## HKS700E SERVICE BULLETIN

**SB-0801**

Low compression caused by excessive wear of exhaust valve guide.

HKS700E from S/N 100440

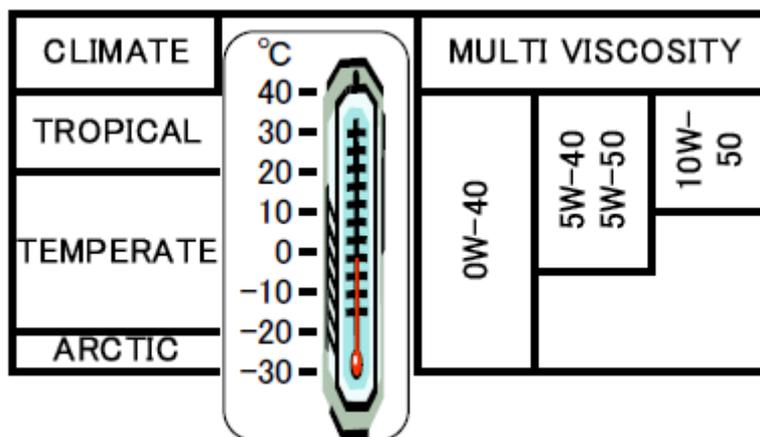
- Change the clip position of JN from 3<sup>rd</sup> to 4<sup>th</sup> (From S/N 100440 to S/N 101319)
- Verify the carburetor setting according to TABLE 1

Upper manifold	Horizontal manifold
MAIN JET (MJ)	125 (130* <sup>1</sup> )	135(140* <sup>1</sup> )
NEEDLE JET (NJ)	2.7	
DIFFUSER (CK)	10	
IDLE JET (PK)	45	
IDLE MIXTURE SCREW	1-1/2 turn	
JET NEEDLE (JN)	251/ 4 <sup>th</sup> groove from top.	
STARTING JET	75	
PISTON (SB)	6

(\*1) Change the MAIN JET when using the fuel with alcohol (From S/N 100440).  
Fuel with more than **5%** alcohol added must not be used.

This new clip position is already in use on the following engines and must be used on the next engine repair or overhaul.

- Commencing with engine S/N 101320
